REVISIONS TO APPROVED SCHEME

REV:	DATE:	DETAILS:
-	20.11.19	Planning Application NMA Review

PROJECT:
John Dalton House
Manchester

TITLE:
Proposed Section
Section CC

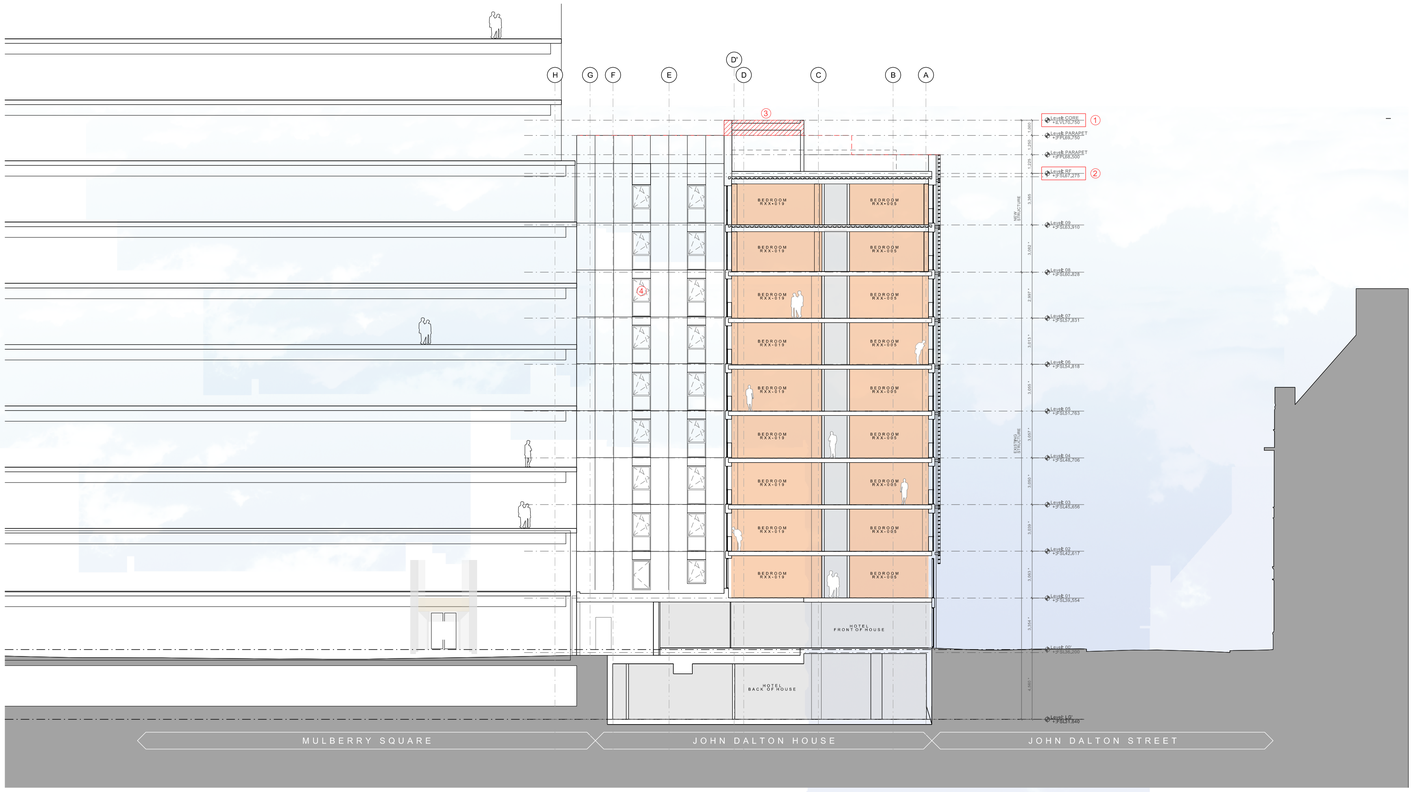
1. Level: FLUE amended to 'CORE' - 150mm increase in height
2. Level: RF - 175mm decrease
3. Plantroom adjustment
4. Window configuration amended to suit agreed Sample Panel
